Draft REPORT

10th meeting of GRRF Informal Working Group on Automatically Commanded Steering Function

Venue: DGEC (Direction Générale de l'Energie et du Climat)
LA DEFENSE Tour Pascal B - 92800 Puteaux, France
Chairman: Mr. Christian Theis (D) and Mr. Hidenobu Kubota (J)
Secretariat: Mr. Jochen Schaefer (CLEPA)
Dates: 11. – 13. January 2017
Website: <https://www2.unece.org/wiki/display/trans/ACSF+9th+session>

With document [ACSF-10-05-Rev.1](#) OICA explained the lane change process

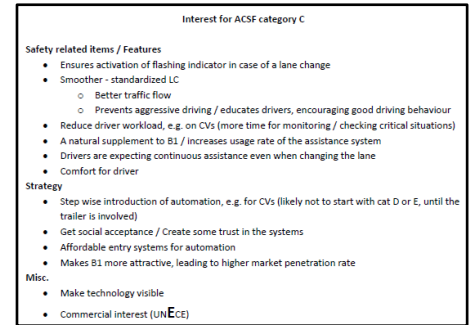
(C-D): are the 15s/30s not too long?

(UK): We should put the 3 flashes in [...]. Maybe we need a time.

- 1) are the 15s/30s fixed in a vehicle type?
- 2) what is happening, if the driver brakes/accelerates while the lane change?

- 1) phase B1 with monitoring of “Hands-on”
- 2) Phase “lane change” without B1. If he is driving here without hands-on, the driver cannot react fast enough, in case the system will switch off.

(D): Would it be necessary to reduce the “hands-on-monitoring” while the lane change manoeuvre to e.g. 3s?

(OICA): This is the maximum, depending also on the road conditions.

(OICA): That should be discussed when we specify the requirements.

- to 1) 15s/30s may vary by speed or maybe when using a caravan
- to 2) if the acceleration will be higher than a certain value, CAT C may switch off

(OICA): The monitoring time for CAT B1 should be used.
